MDX-40

SONY

SERVICE MANUAL

CORRECTION - 1

1. DISASSEMBLY (Supplement-1 see page 2)

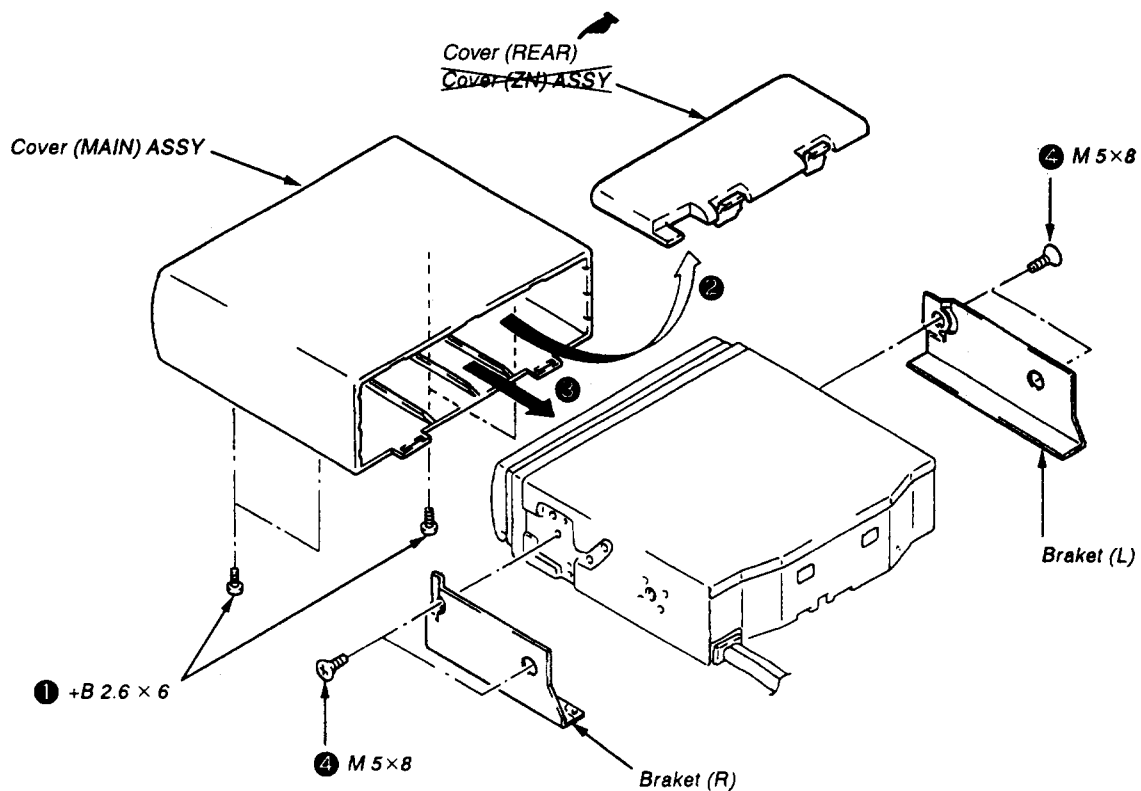
1-1. COVER (MAIN), BRACKET L/R

1-2. COVER (ZN) ASSY

2. EXPLODED VIEWS (Service Manual see page 25 and Supplement-1 see page 36)

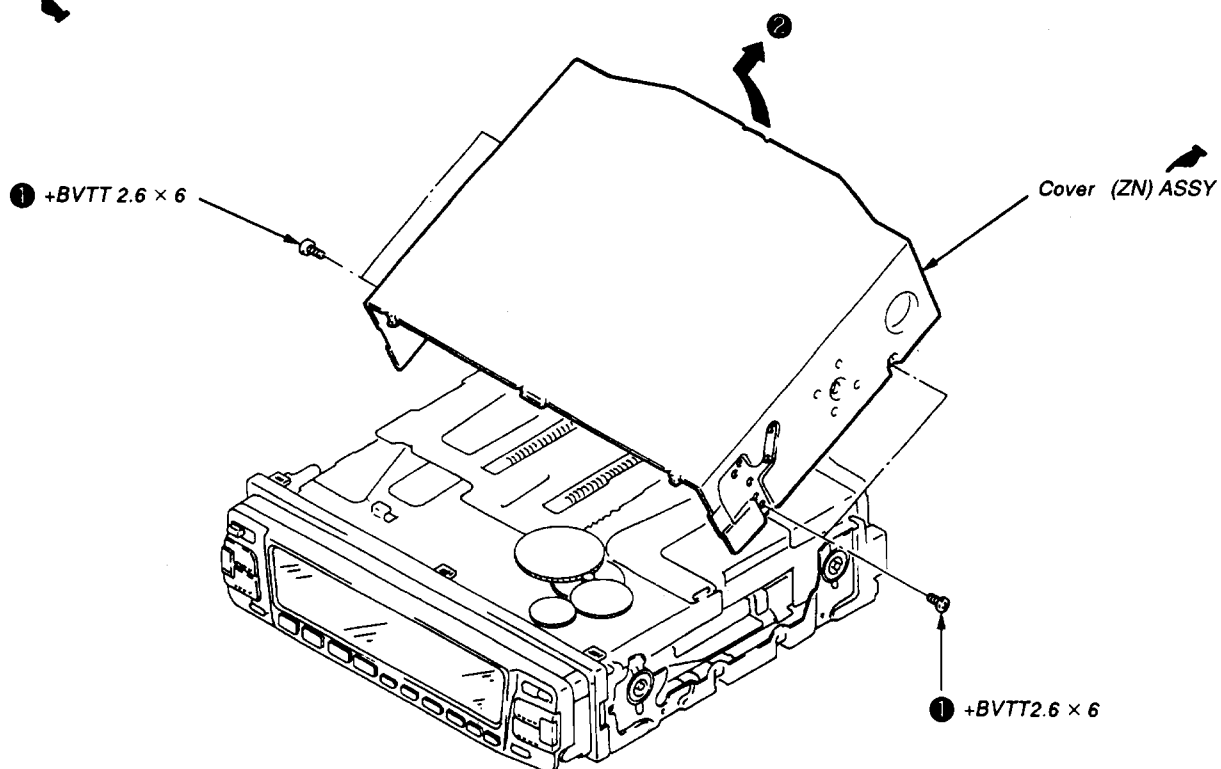
: Changed portion
